SUBJECT: Offsite Dose Calculation Manual
Revision 11

The General Office Radwaste Engineering staff is transmitting to you this date, Revision 11 of the Offsite Dose Calculation Manual. As this revision only affects Oconee Nuclear Station, the approval of other station managers is not necessary. Please update your copy No. 1, and discard affected pages.

JUSTIFICATIONS FOR REVISION 11

Figure A1.0-1 is a schematic representation of the liquid radwaste system at Oconee.

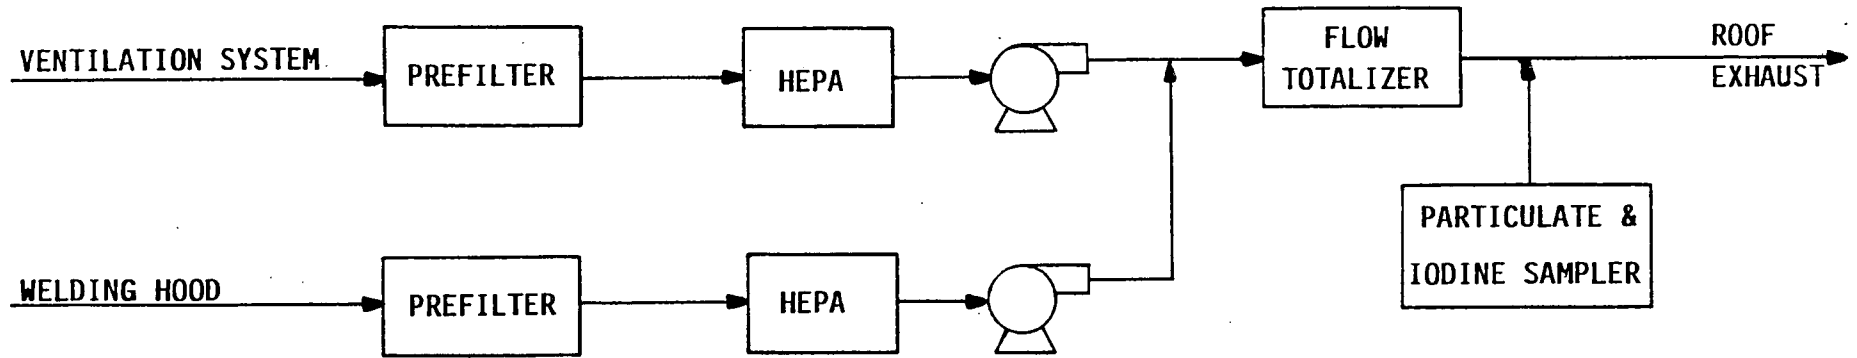
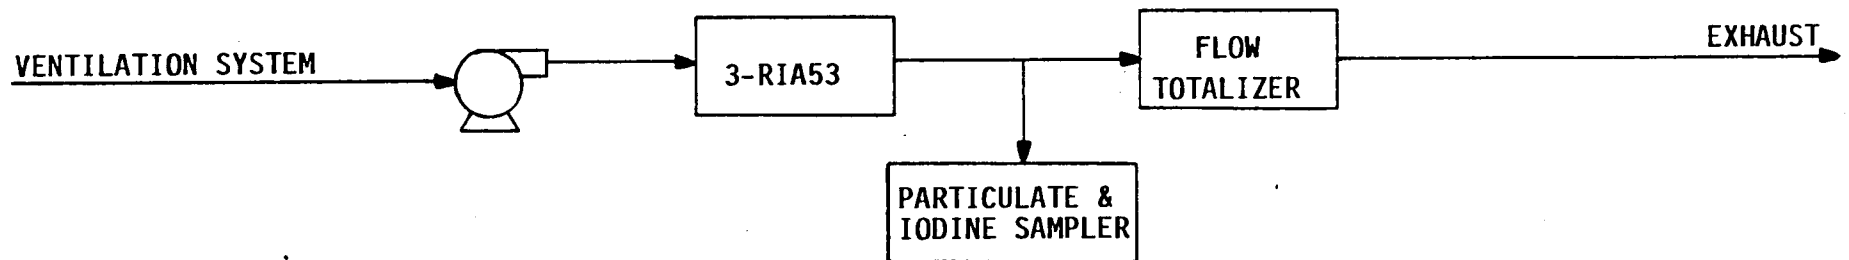
Section A1.1(E) (Page A-1)	Added reference to VR dryer located in the new Radwaste Facility.
Figure A1.0-1	Incorporated Radwaste Facility into drawing.
Figure A1.0-2 (Page 4 of 4)	Incorporated Radwaste Facility into drawing.
Section A2.1.1 (Page A-3)	Changed title; added/changed words for clarification purposes; no change in meaning.
Section A2.1.2 (Page A3-a)	New page, Updated description of #3 Chemical Treatment Pond and incorporated Radwaste Facility into description.
Page A-4	No change in content, only location of information.
Page A-5	No change in content, only location of information.
Page A-6	No change in content, only location of information.
Section A3.0 (Page A-6)	Added information to show differences between gas monitor systems of the Radwaste Facility and other station gas monitors.
Section A3.1.1 (Page A-6)	Retitled section to clarify topic; added detail to to the information given on monitor setpoints.
